Application of Stix & Stones Homes for a major modification of zoning conditions #1 and #2 pursuant to Z-22-1245596 to increase the number of units and construct a single-family detached cottage development at 1484 & 1520 Columbia Drive.

PETITION NO: D1-2023-1142 CZ-23-1246630

LOCATION: 1484 & 1520 Columbia Drive, Decatur, Georgia 30032

STAFF ANALYSIS

ORIGINAL SITE PLAN, 08/24/2023

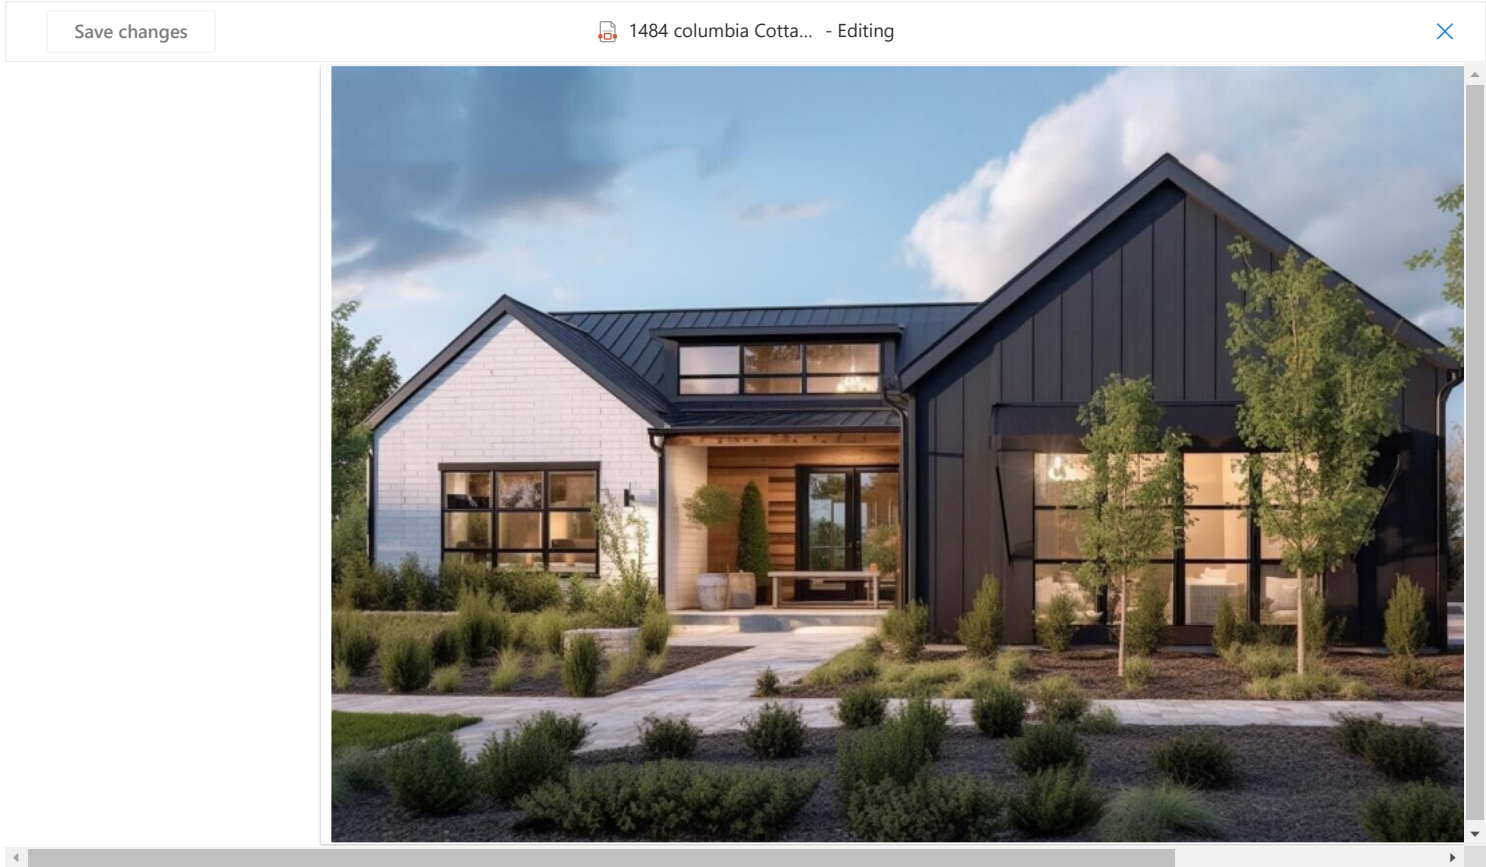
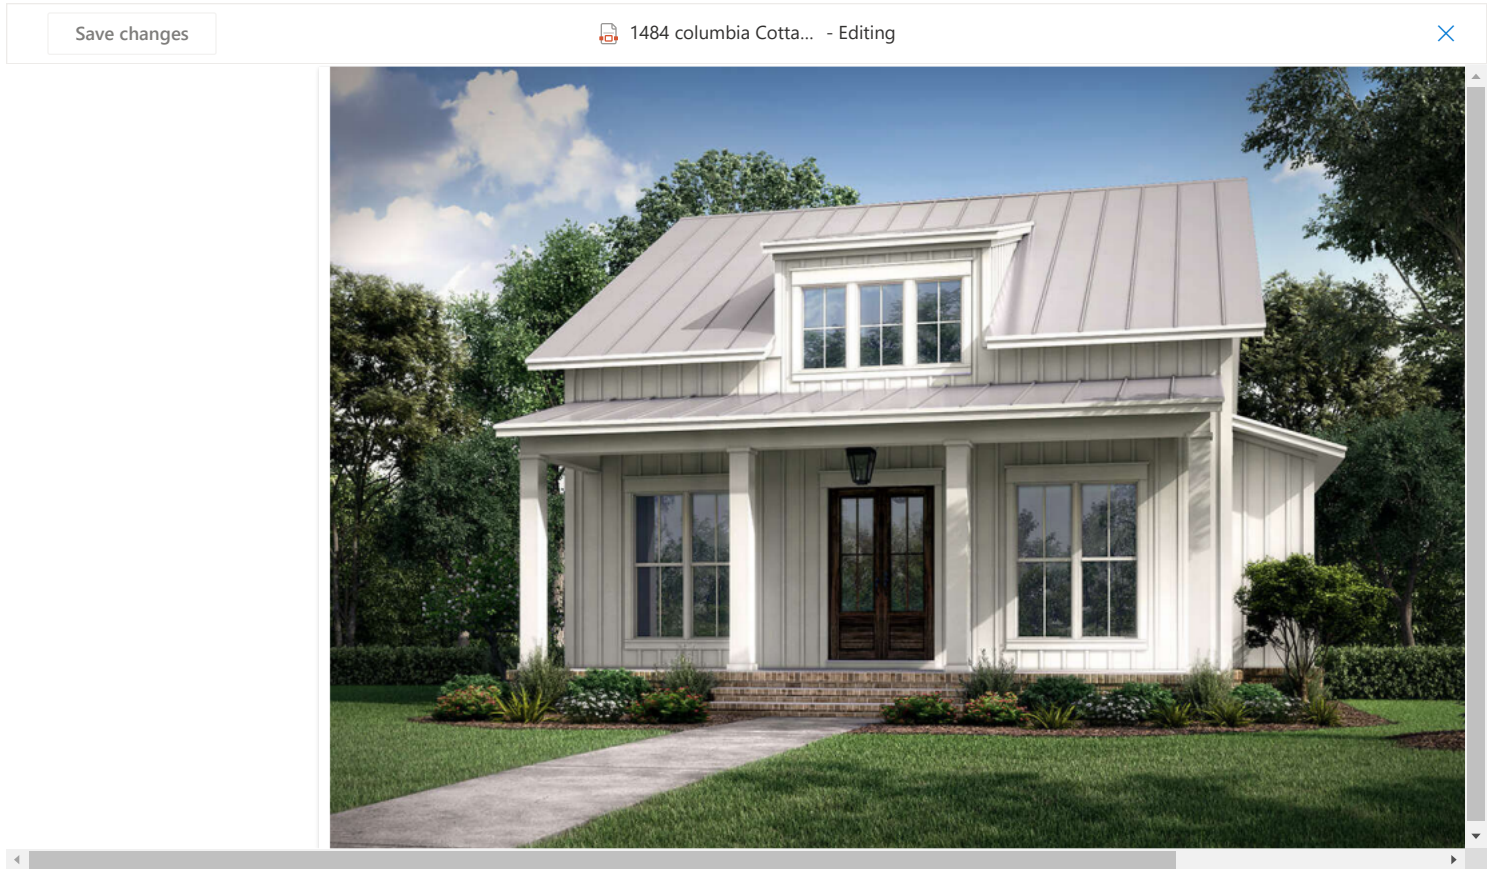
The original site plan with the proposal, dated August 24, 2023 and titled “*Columbia Cottages*”, showed clusters of cottage dwellings centered around several courtyards which qualify as areas of enhanced open space typical of cottage developments. This site plan, however, contained numerous zoning deficiencies,

including a lack of streetscaping, lot compatibility, and compliance with cottage development standards that were in place at the time. Significant deficiencies with proposed stormwater detention facilities were noted by Land Development, Roads and Drainage, and Watershed. As a result, at its meeting on November 16, 2023, the Board of Commissioners granted this case a *two-cycle deferral* to give the applicant sufficient time to redesign their proposal.

A revised site plan dated January 17, 2024 shows an updated design that addresses a majority of concerns raised by staff with the initial submittal. Landscaping and streetscaping has been provided that meets the requirements of Section 5.4.3. The majority of the proposed cottages are clustered around a central enhanced open space or common area; an underground stormwater detention facility is provided underneath this open space and a stormwater discharge point is provided in the extreme eastern corner of the development site. On February 15, 2024, a roundtable discussion was held with the applicant and members of various County departments; many of the previous deficiencies were deemed to be adequately addressed with the new proposal.

However, there are still some site plan issues that need to be addressed. While a better display of pedestrian connectivity has been provided compared to the original site plan, Planning Staff recommends an additional pedestrian path be provided on the eastern side of the proposed Lot 9 to connect with the proposed sidewalk improvements along Columbia Drive. The proposed Lot 16, while fronting what is noted as enhanced open space, is isolated from the other lots. The majority of Lots 1-9 do not appear to comply with Section 5.7.9. (F) of the Zoning Ordinance which requires that parking shall be provided so that each unit is no further than 200 feet from a parking area. Driveways or parking pads appear to be provided for Lots 10-15, which do not meet the intent of the cottage design guidelines for the units to be oriented toward a open space courtyard with any vehicular access from the rear of the lot. It should be noted, however, that the revised site plan was designed according to older cottage development standards and not those per the adoption of Section 5.7.9. of the *Zoning Ordinance*. The text amendment allows for a more flexible cottage design by abolishing lot area, lot width, setbacks, and lot coverage requirements for individual lots. While dwellings must be located no closer than five (5) feet from an enhanced open space/common area and no closer than 10 feet from each other (with some exceptions), the new development standards allow for a much more compact clustering of units. This, in turn, can allow for additional (or the relocation of currently proposed) infrastructure on-site.

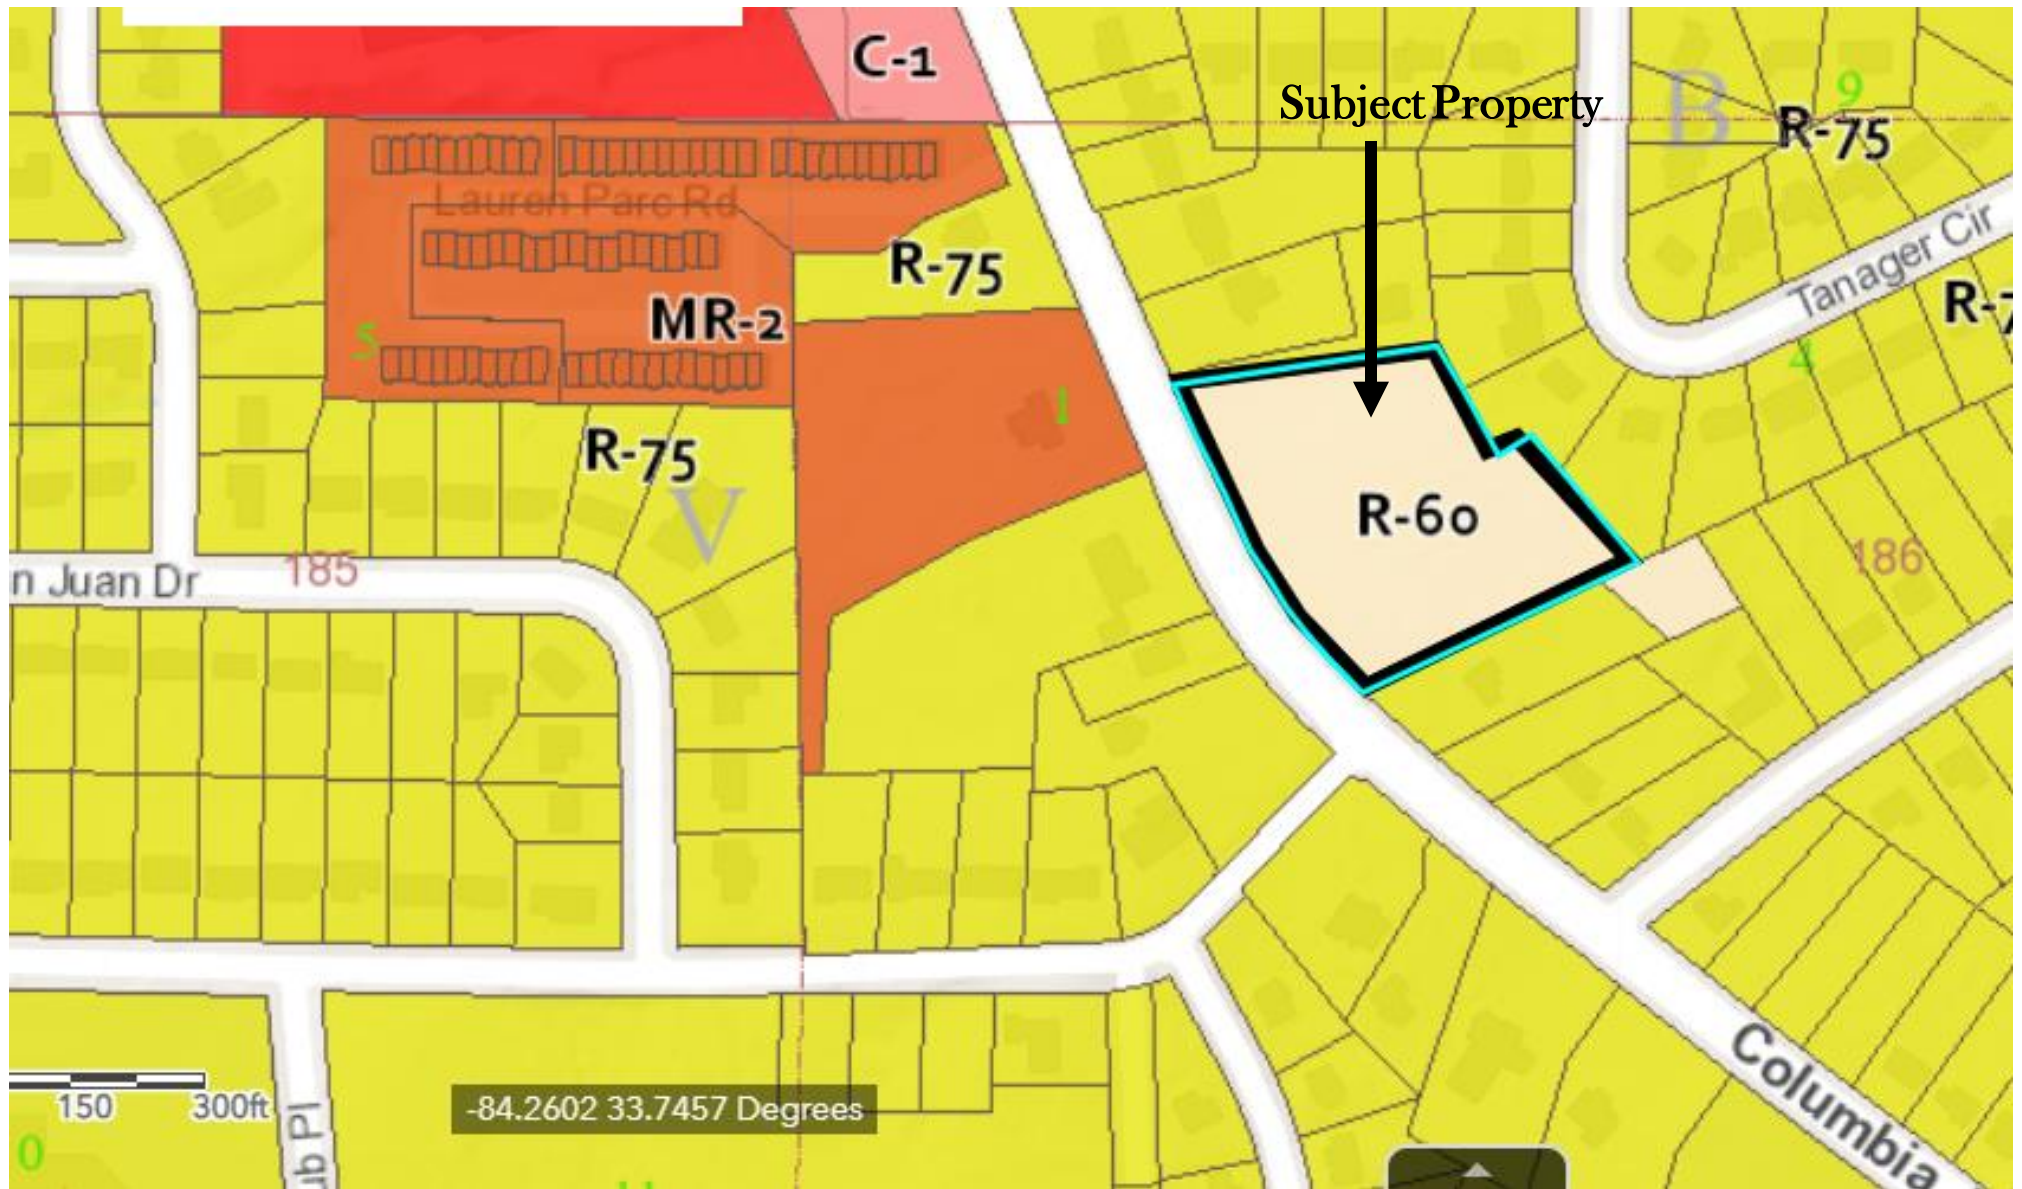
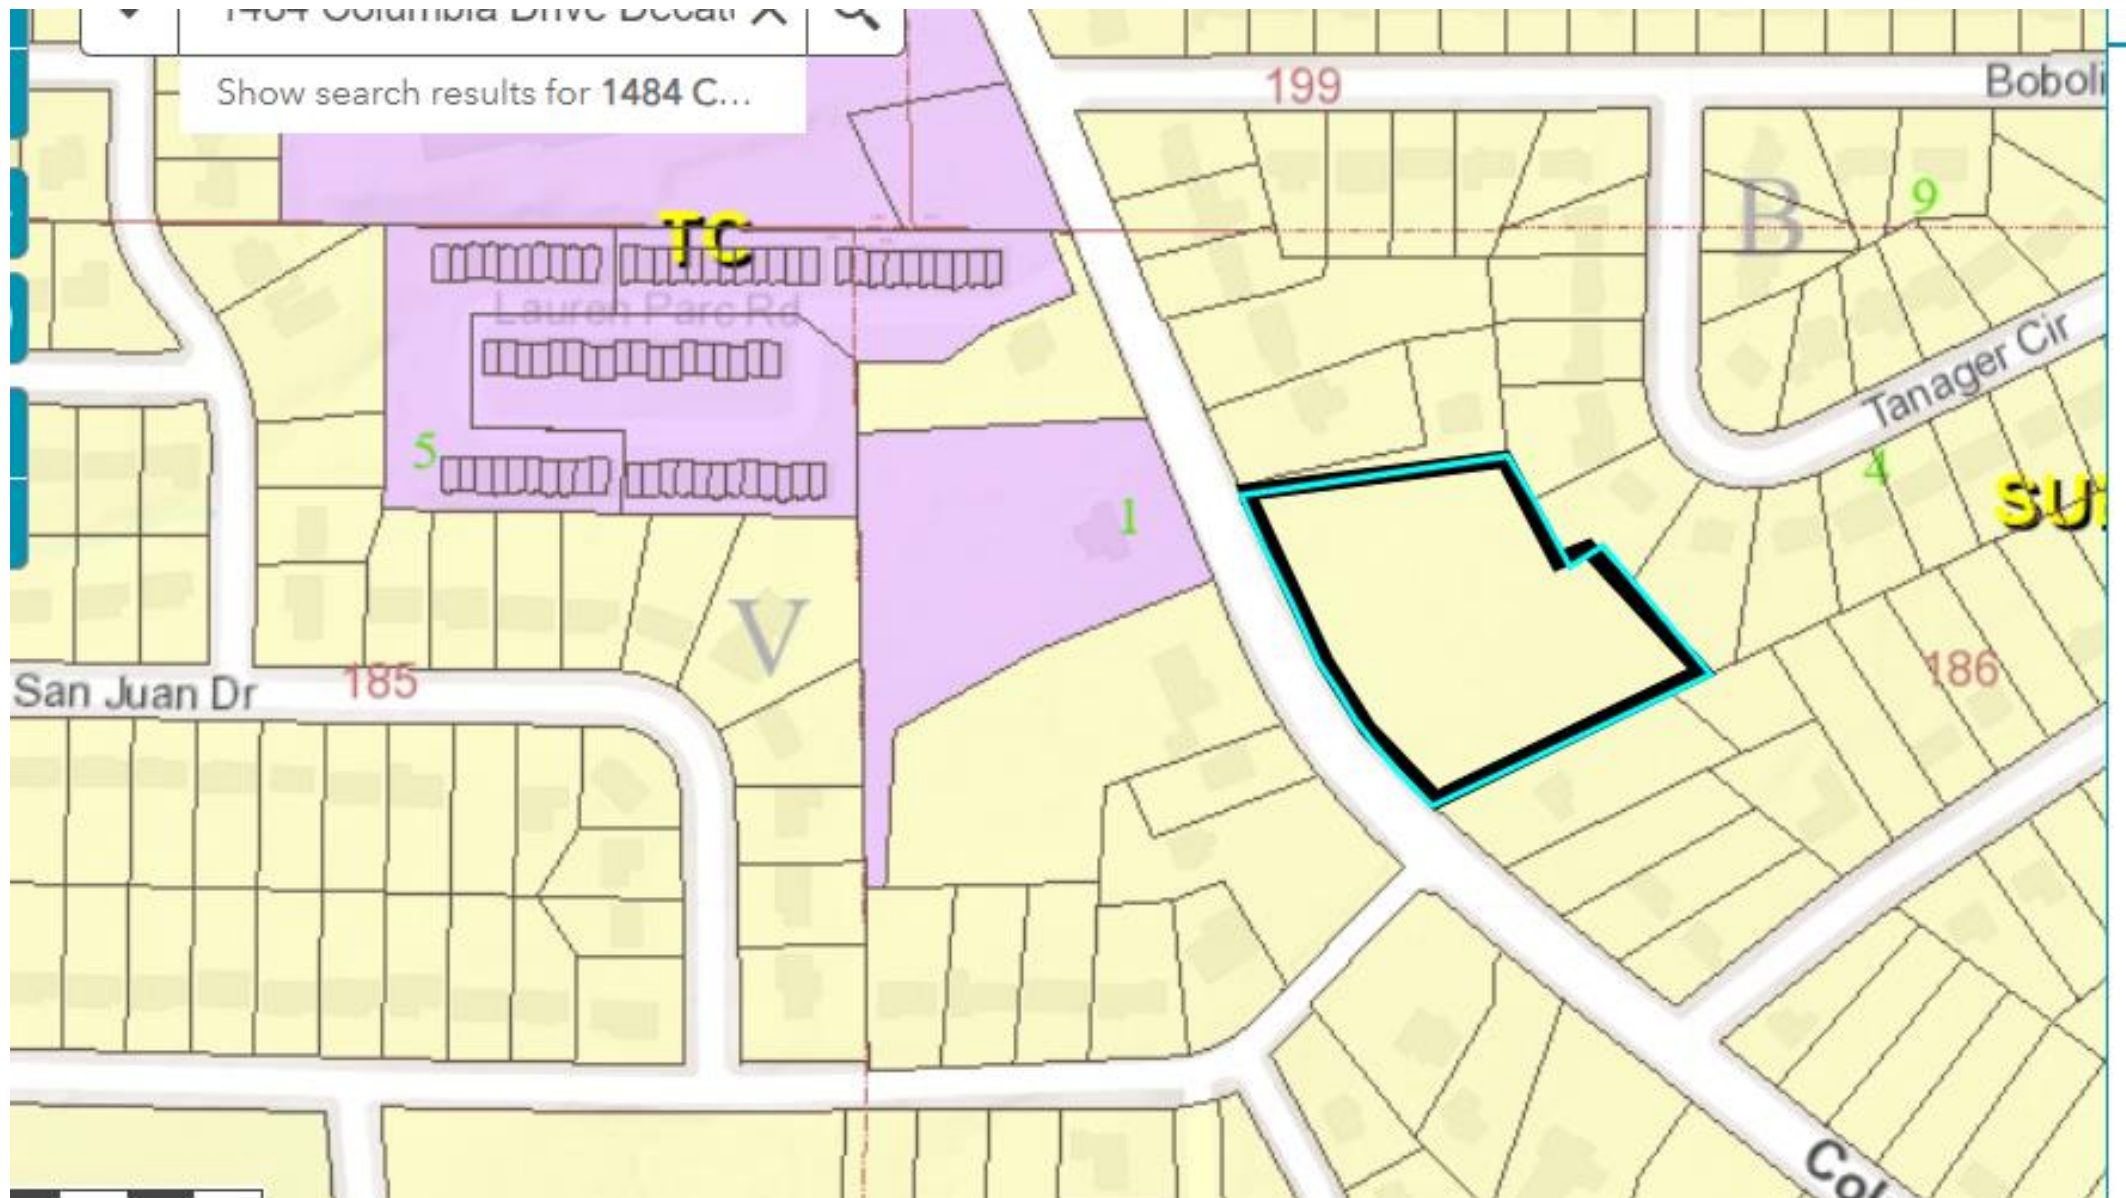
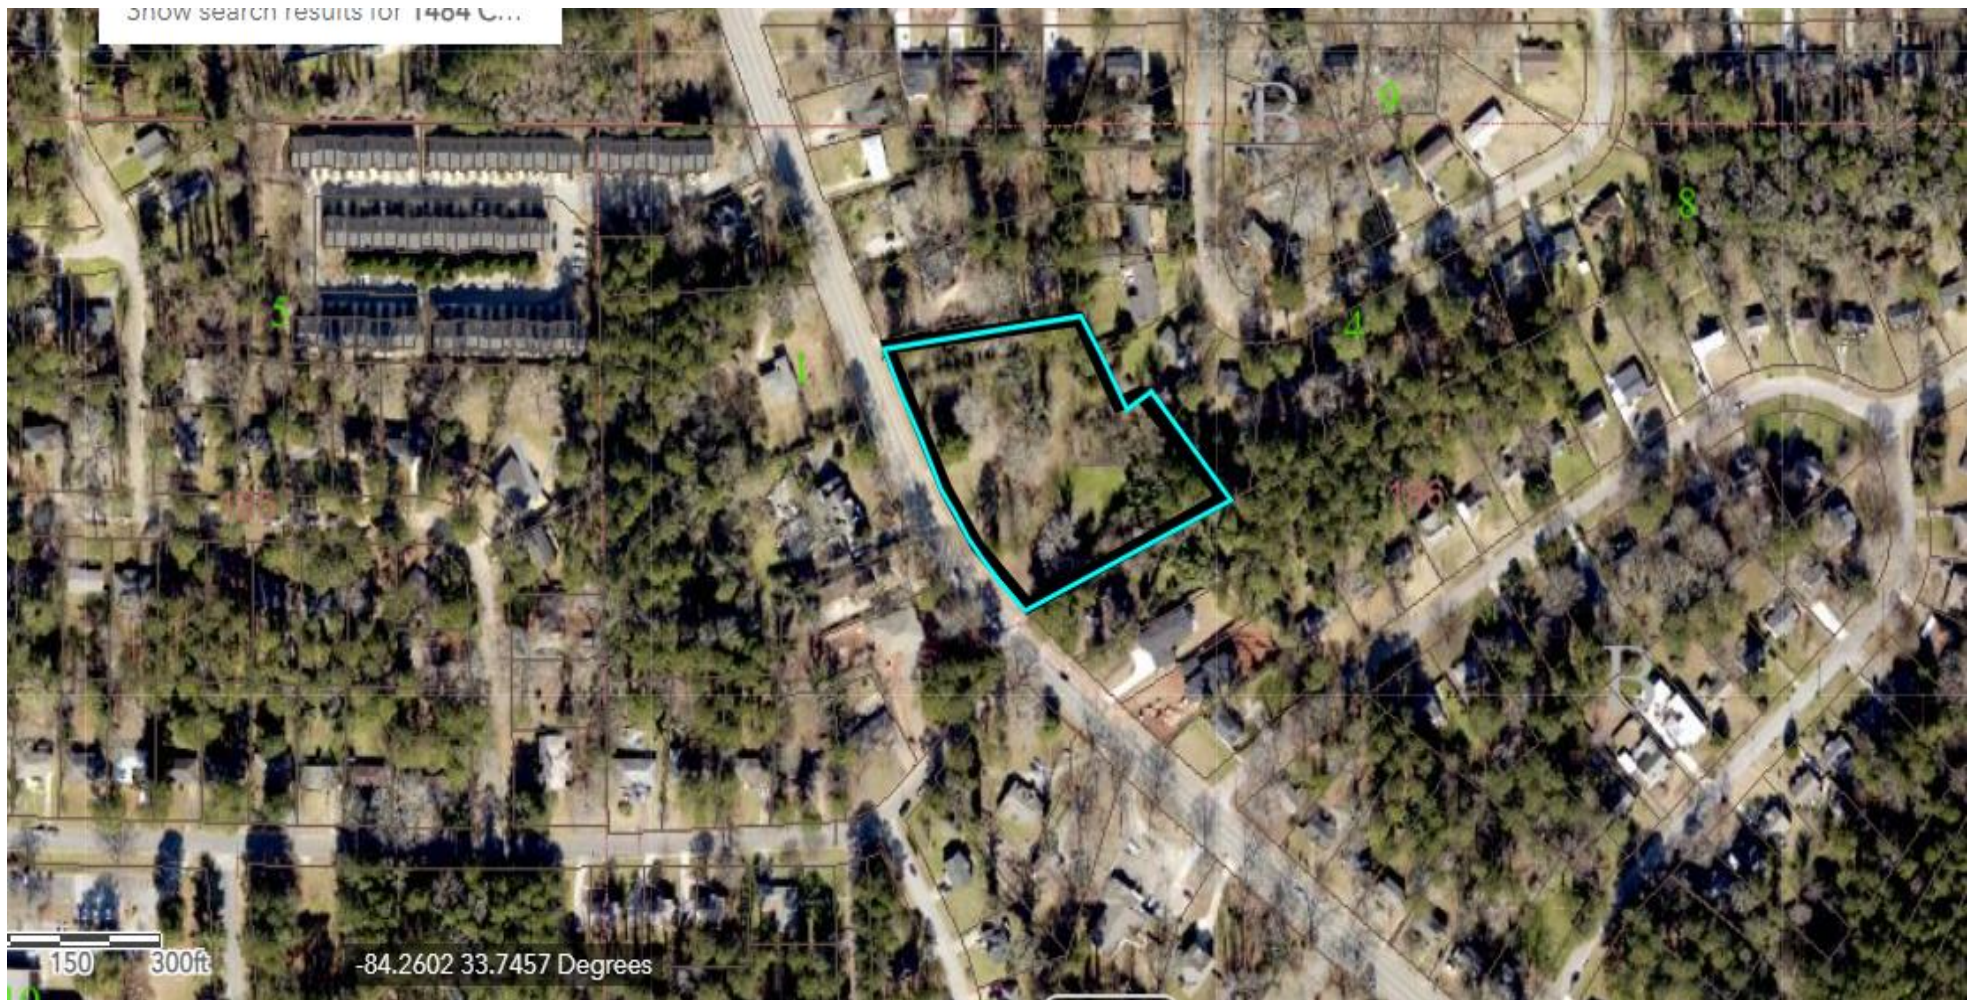
- (3) Based on the current/existing topography, the site points to two receiving/study points (see the screenshot below). However, on the proposed conceptual plan, there is only one location indicated as "water quality pond". If you will have one location of the stormwater mgt facility, you will need to explain/confirm: (1) that you will be changing the current drainage pattern by grading the site or designing your storm pipes network to achieve all runoff to be directed to the northeast corner, so that no runoff is to be expected at the southeast corner in the post-development condition OR (2) how the stormwater management requirements will be addressed at the study point in the southeast corner considering all the proposed impervious compared to the pre-development conditions.

Impact on property (flood, erosion, sedimentation) under existing zoning: Flood impact on this property is expected to be minimal since it is in zone X which is outside the floodplain and otherwise referred to as Special Flood Hazard Area. Erosion and sedimentation is also not expected to be prevalent due to the topographic gradient on of the property.

Required detention facility(s): Detention/retention facilities would be required for stormwater management per section 14-40 and other relevant code sections of DeKalb County codes of ordinance as applicable.

No objection to modification to the zoning conditions as applicant has requested. A total compliance with the relevant sections of the County code of ordinance relating to erosion, sedimentation and pollution control is required. Also, Sec. 14-40 and 14-42 must be complied with.
